# Product Change Notification - SYST-17HDJP713

<b>Date:</b>	18 Apr 2017
<b>Product Category:</b>	Ethernet Controllers
<b>Affected CPNs:</b>	 
<b>Notification subject:</b>	Data Sheet - LAN9218 High-Performance Single-Chip 10/100 Ethernet Controller with HP Auto-MDIX Support
<b>Notification text:</b>	SYST-17HDJP713

## High-Performance Single-Chip 10/100 Ethernet Controller with HP Auto-MDIX Support

**FIGURE 1-1: SYSTEM BLOCK DIAGRAM**

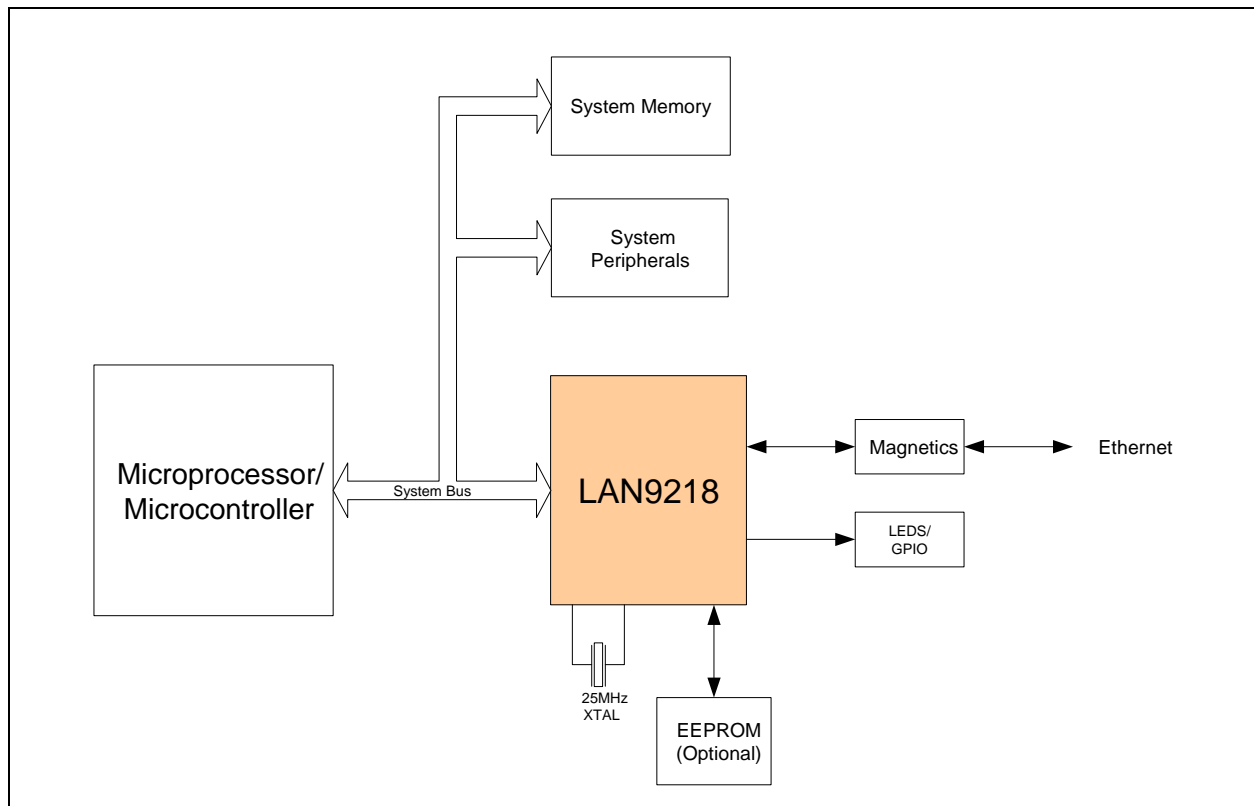
Revision Level & Date	Section/Figure/Entry	Correction
Rev. 2.3 (07-30-08)	<a href="#">Block Diagram</a>	Figure modified removing "system memory" and double-sided arrow on top of the "processor" block.
Rev. 2.3 (08-18-08)	<a href="#">Note 7-8 on page 118</a>	Note following I/O Buffer Characteristics table modified:  Changed from: ".....the per-pin input leakage is 10 divided by the maximum input leakage current." to: ".....the per-pin input leakage is the maximum input leakage current divided by 10."
Rev. 2.2 (06-19-08)	<a href="#">FIGURE 1-2: "Internal Block Diagram"</a>	Diagram redone. The second PLL regulator was added to the diagram. The word "Core" was added to the regulator block title. Added note to VDD_CORE/VDD18CORE and VDD_PLL that states "These pins must not be used to supply power to other external devices."
Rev. 2.2 (06-10-08)	<a href="#">Auto-negotiation Advertisement on page 95</a>	Bits 9 and 15 relabeled as Reserved, Read-Only (RO), with a default of 0.

Rev. 2.1 (05-13-08)	<a href="#">Section 1.1, "Block Diagram"</a>	Removed the system memory block and arrow above the microprocessor/ microcontroller
Rev. 2.0 (04-11-08)	<a href="#">Section 7.6, "DC Electrical Specifications," on page 117</a>	Input leakage current values added
Rev. 1.92 (10-22-07)	<a href="#">2.0 Pin Description and Configuration on page 8</a>	Pin assignment information re-organized into separate table.
	<a href="#">EECLK pin description in 2.0 Pin Description and Configuration on page 8</a>	Note added to EECLK pin description to indicate proper usage.
